SUBJECT: SAFETY EVALUATION OF TOPICAL REPORT WCAP-15603, REVISION 1,
"WOG 2000 REACTOR COOLANT PUMP SEAL LEAKAGE MODEL FOR
WESTINGHOUSE PWRS" (TAC NO. MB1714)

SAFETY EVALUATION BY THE OFFICE OF NUCLEAR REACTOR REGULATION

WCAP-15603, REVISION 1, "WOG 2000 REACTOR COOLANT PUMP

SEAL LEAKAGE MODEL FOR WESTINGHOUSE PWRS"

**WOG 2000 REACTOR COOLANT PUMP SEAL LEAKAGE MODEL
FOR HIGH-TEMPERATURE O-rings
(AS MODIFIED BY THE STAFF SAFETY EVALUATION)**

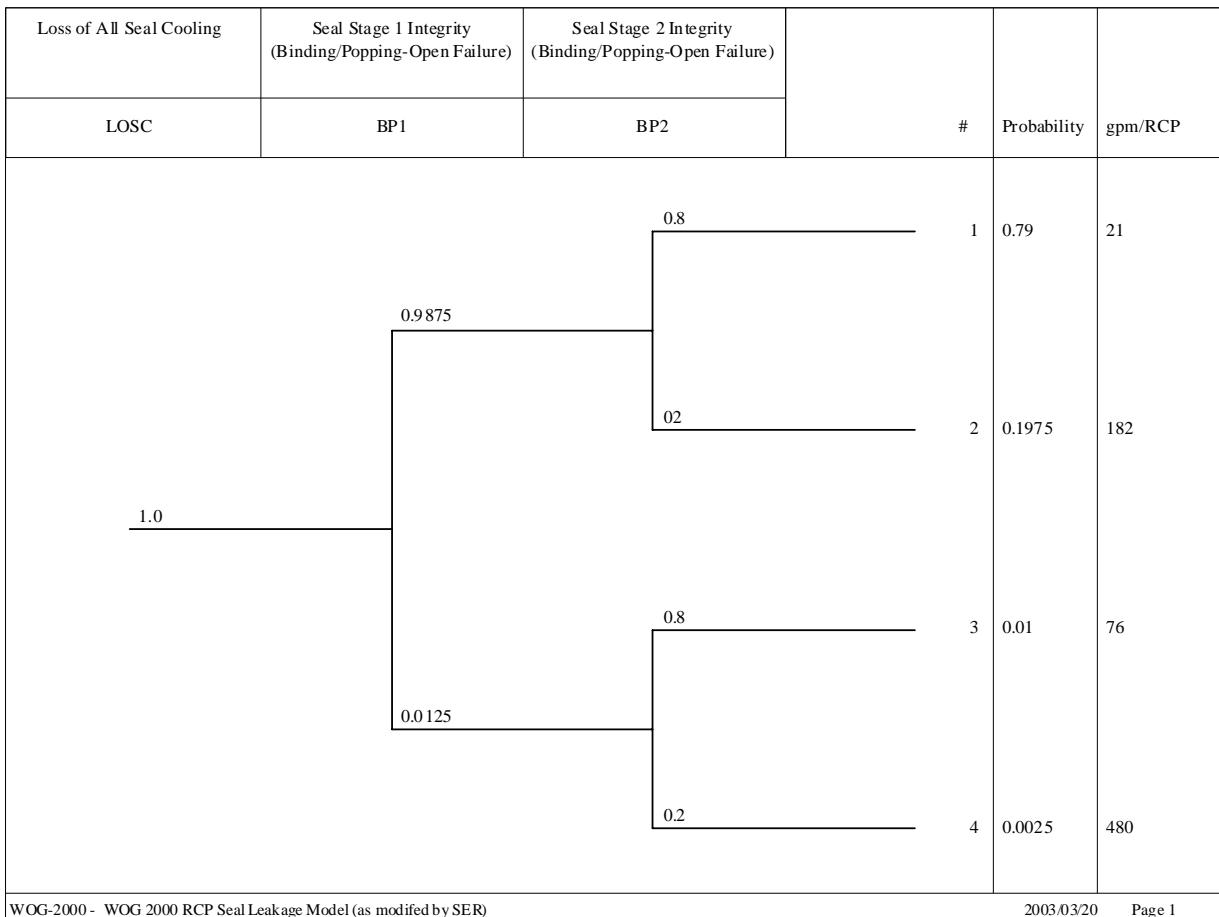
The failure of the third seal stage is not shown since it is assumed to fail (i.e., has a failure probability of unity) if the second seal stage fails and is assumed irrelevant if the second seal stage does not fail. This effectively reduces the WOG 2000 model from five sequences to four sequences.

For the first 13 minutes after the loss of all seal cooling, the leakage rate is 21 gpm (i.e., Sequence 1 with a probability of unity). The probability of O-ring extrusion failure is zero for the high-temperature O-rings, as long as the plant cooldown will result in a RCS pressure less than 1710 psi within 2 hours. Thus, under these conditions after the first 13 minutes, the leakage rate is as provided in the figure above with the associated sequence probabilities. If the plant cooldown will not result in an RCS pressure less than 1710 psi within 2 hours, then extrusion failure of the O-rings must be addressed with a failure probability of 0.5 for the high-temperature O-rings.

**RHODES REACTOR COOLANT PUMP SEAL LEAKAGE MODEL
FOR "OLD" O-rings
(BASED ON NUREG/CR-4906P AND NUREG/CR-5167)**

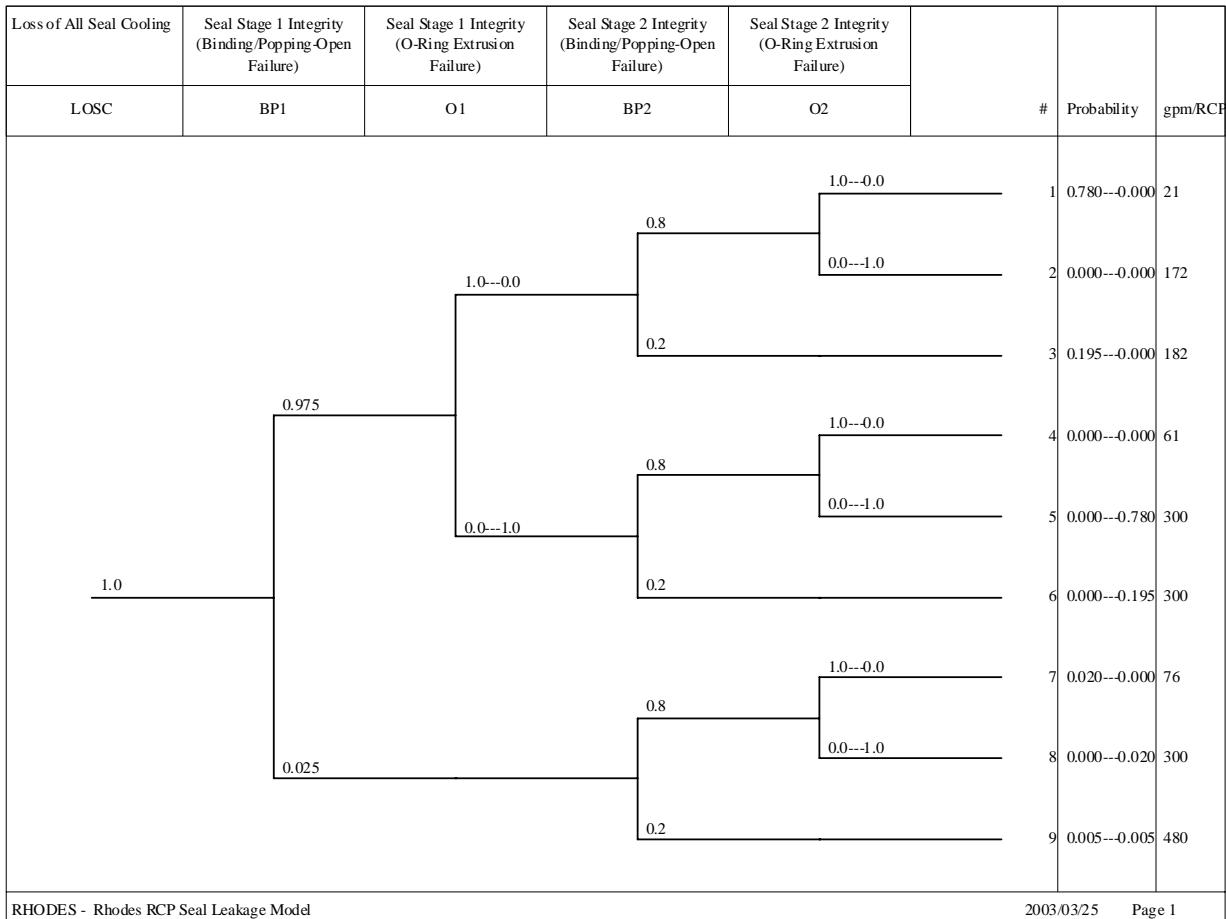
The failure of the third seal stage is not shown since it is assumed to fail (i.e., has a failure probability of unity) if the second seal stage fails and is assumed irrelevant if the second seal stage does not fail. This effectively reduces the Rhodes model from seventeen sequences to nine sequences.

For the first 13 minutes after the loss of all seal cooling, the leakage rate is 21 gpm/RCP (i.e., Sequence 1 with a probability of unity). The probability of O-ring extrusion failure is zero for the first two hours, but is unity after the first two hours. Therefore, after the first 13 minutes and up to 2 hours, the leakage rate is as provided in the figure above with the first probability value given in the figure. After 2 hours, the leakage rate is as provided in the figure above with the second probability value given in the figure.
